## REMARKS

MARKED UP COPY SHOWING CHANGES

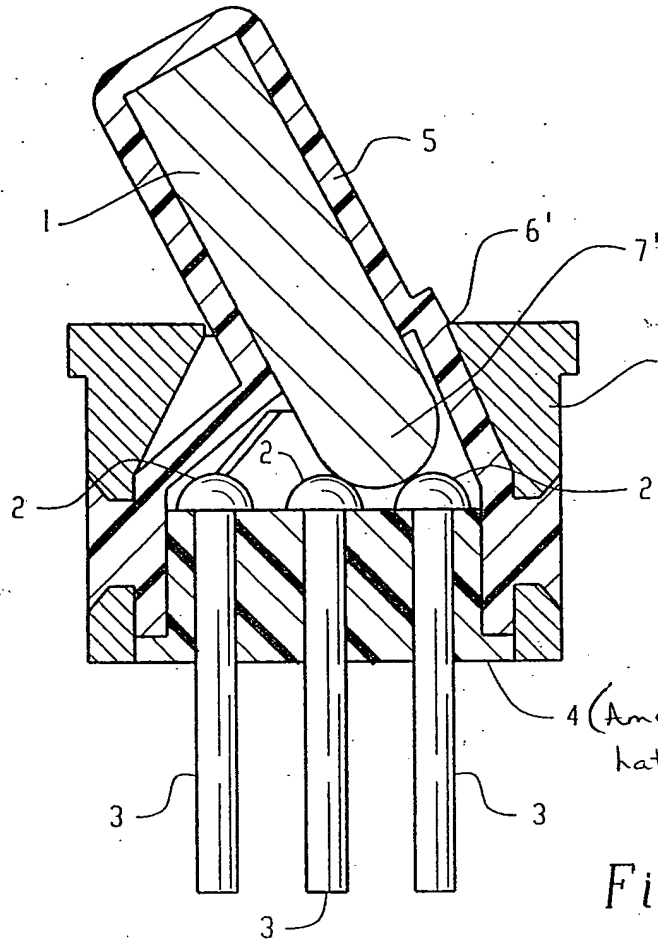
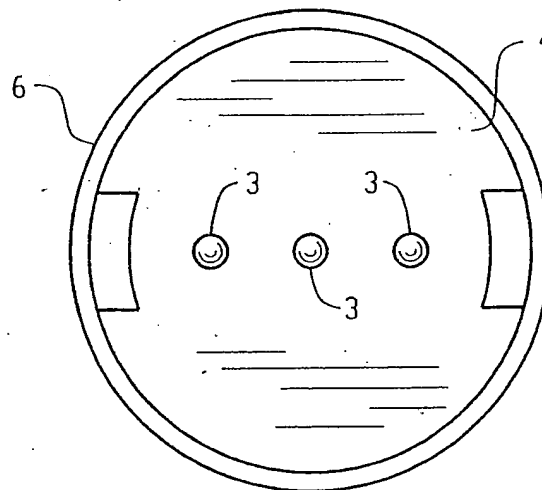
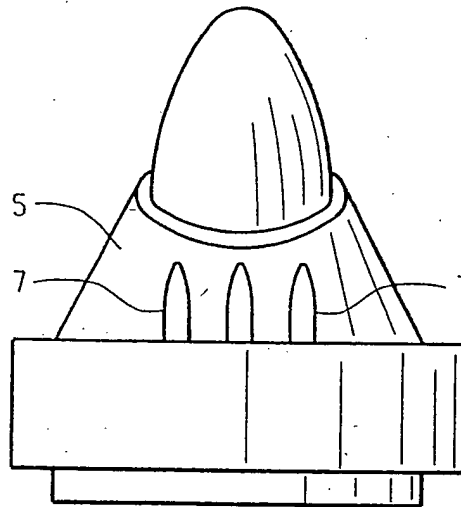
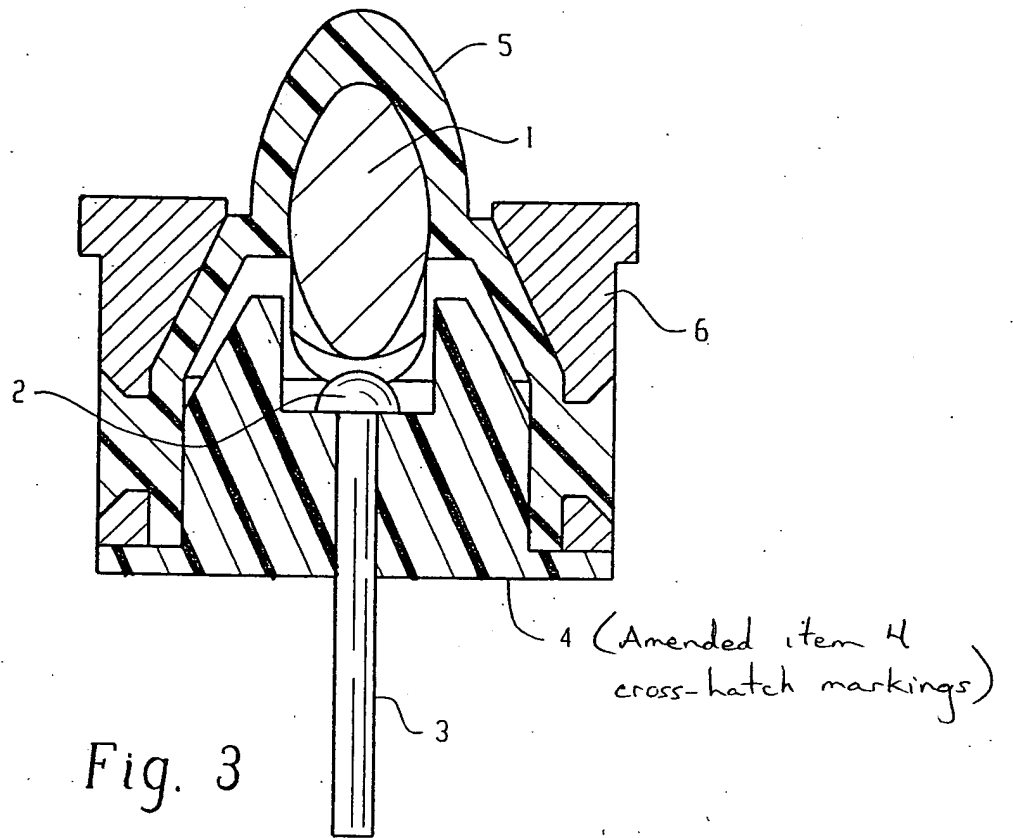
Regarding the objection to the drawings, applicants propose amending Figures 1, 3 and 5-7, as indicated in red ink, to properly cross-hatch the sectioned insulating materials. A set of corrected drawings is enclosed herewith, and the Examiner's approval of the proposed drawing changes is requested.
